**Re: 13CVCP125M
E-Des # 13EHAZ218M
464 West 130th Street
Remedial Action Work Plan (RAWP) Stipulation List**

GEI Consultants, Inc. of New York hereby submits a Remedial Action Work Plan (RAWP) Stipulation List for the Site to the New York City Office of Environmental Remediation (OER) on behalf of Big Apple Developers. This letter serves as an addendum to the RAWP to stipulate additional content, requirements, and procedures that will be followed during the site remediation. The contents of this list are added to the RAWP and will supersede the content in the RAWP where there is a conflict in purpose or intent. The additional requirements/procedures include the following Stipulation List below:

Figure 3

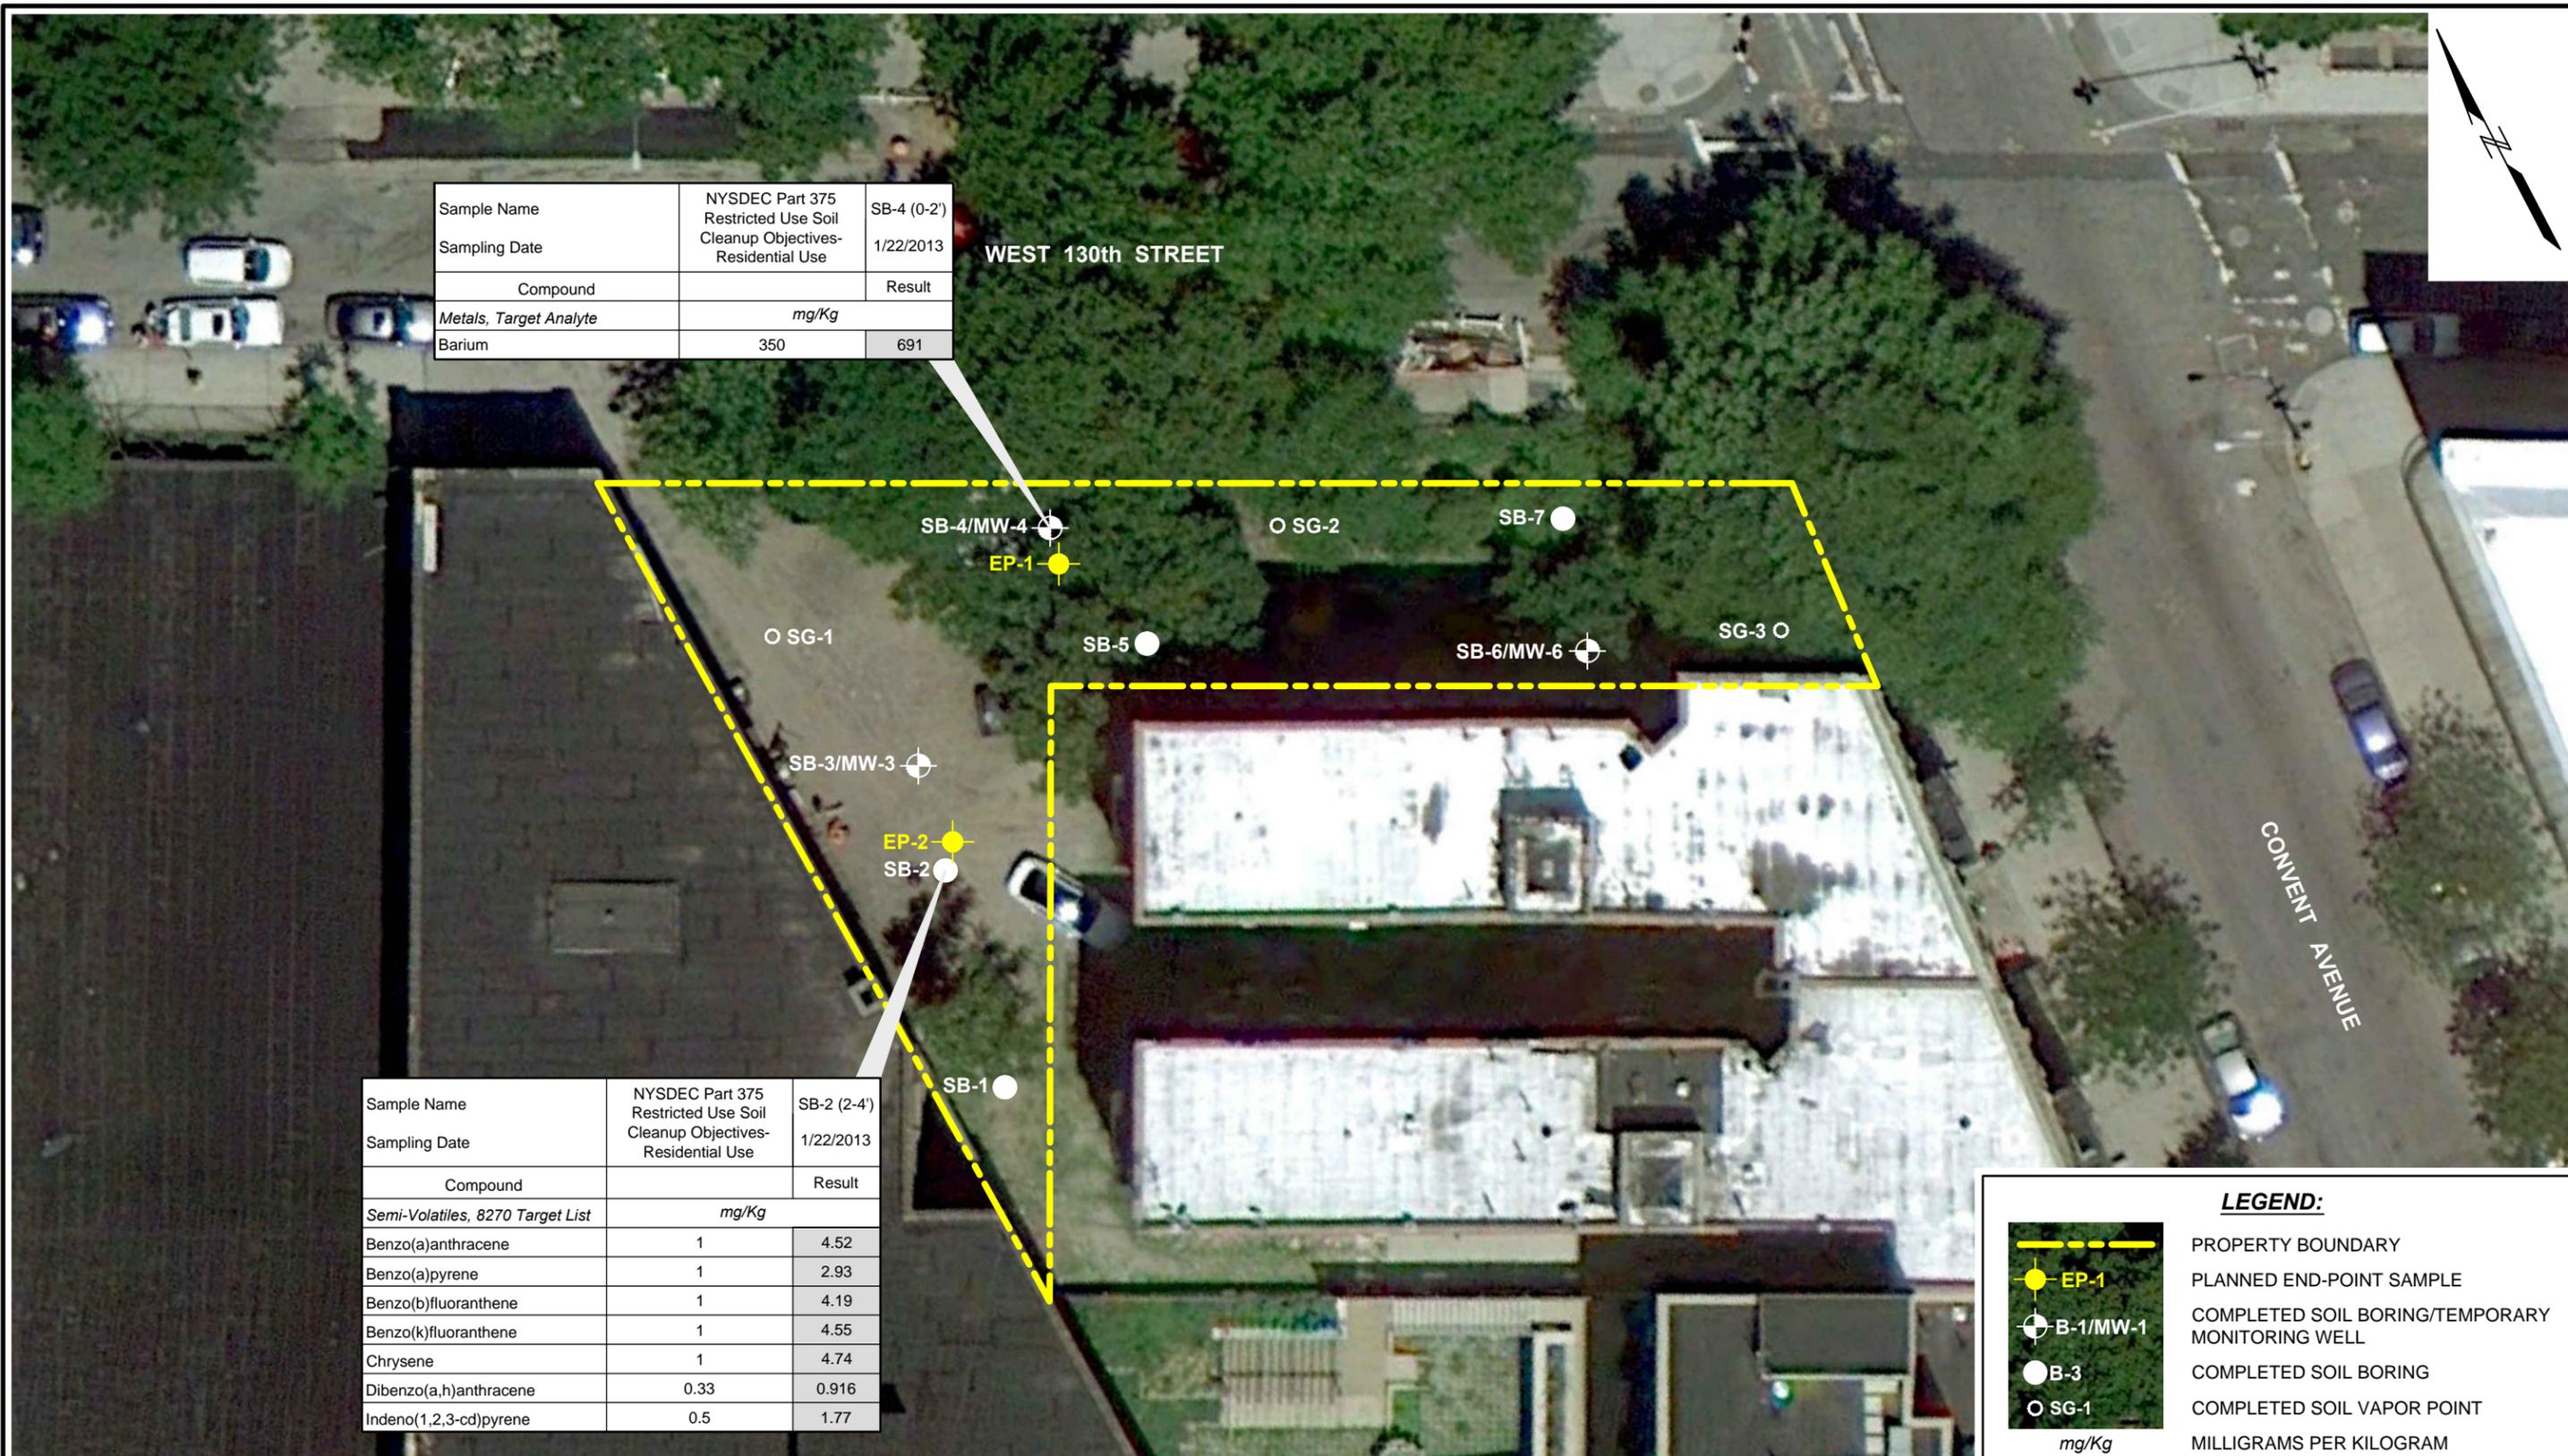
7. Collection and analysis of two (2) end-point samples from the bottom of the excavation will be collected to evaluate the performance of the remedy with respect to attainment of Track 1 SCOs. A map indicating end-point sampling locations is attached in **Appendix 3**. Samples will be analyzed for contaminants of concern (SVOCs and Metals).

SK-001.00
OF

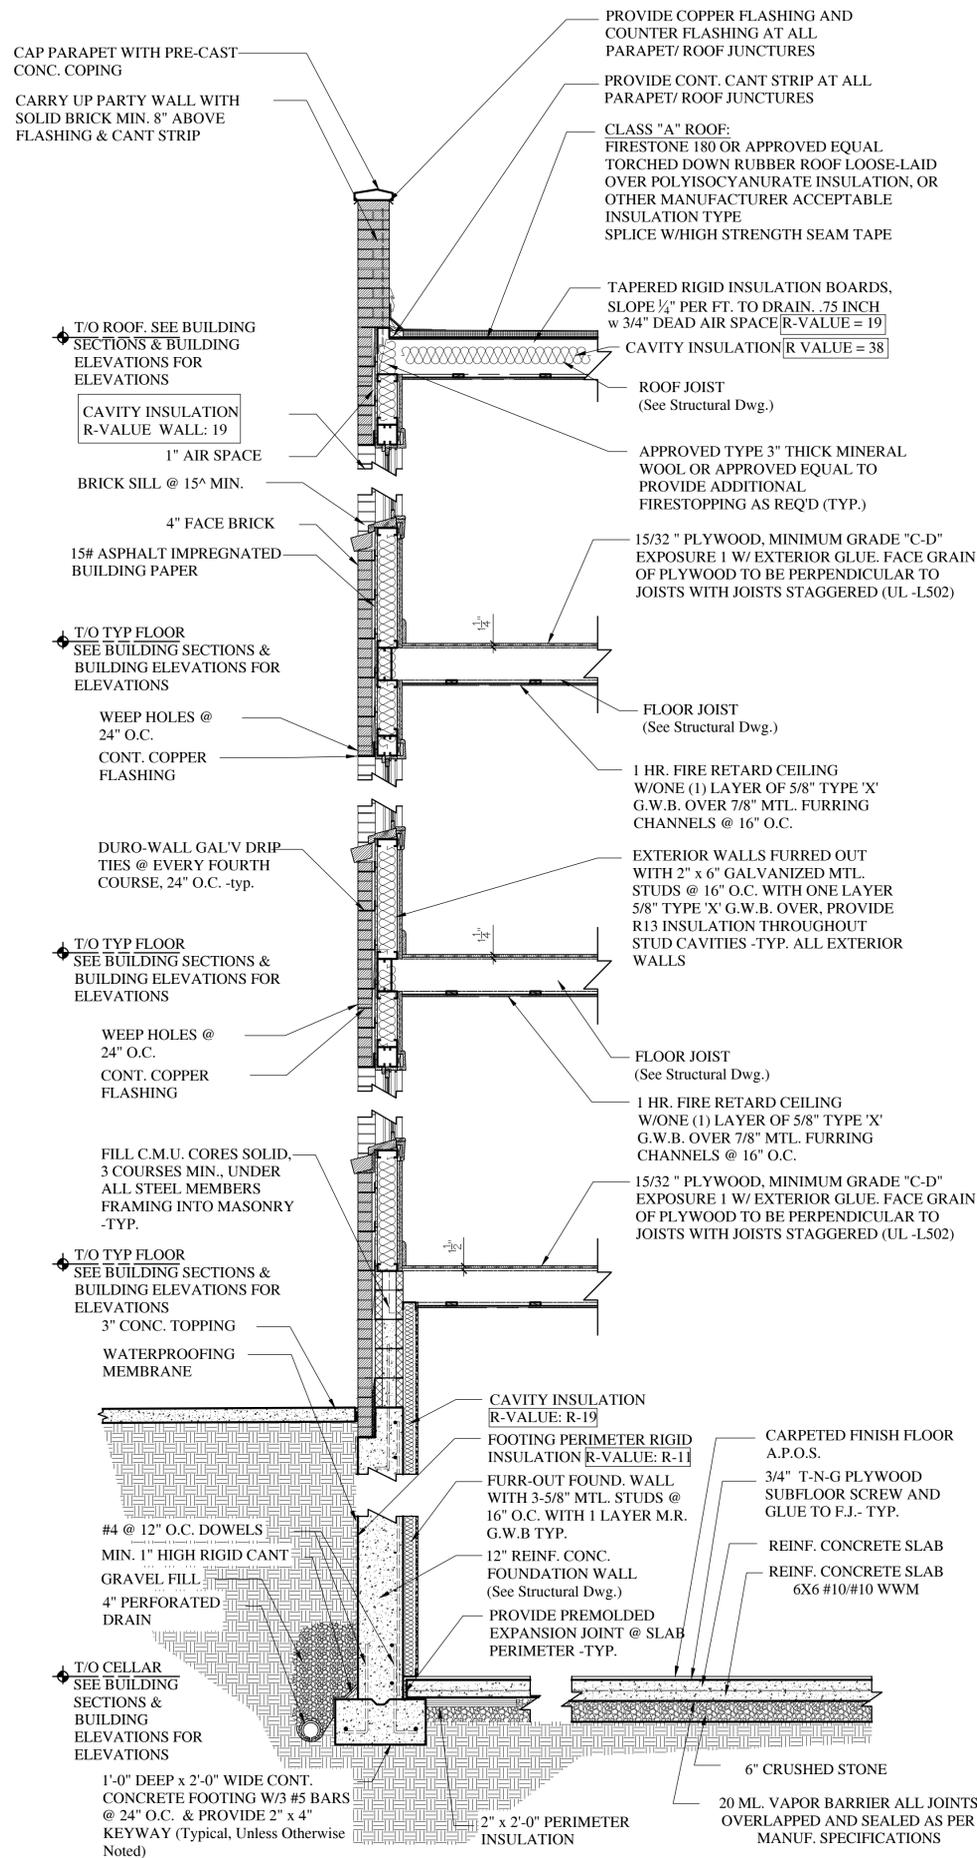
11. A 20-millimeter vapor barrier will be installed beneath the structure's slab and along foundation sidewalls. The barrier chosen for this project is manufactured by Raven Industries, Inc., Vapor Block Plus VBP20 20. **Appendix 7** provides manufactures specifications and PE/RA certified building plans with the extent of the vapor barrier installation details (penetrations, joints, etc.) with respect to the proposed foundation, footings, etc.
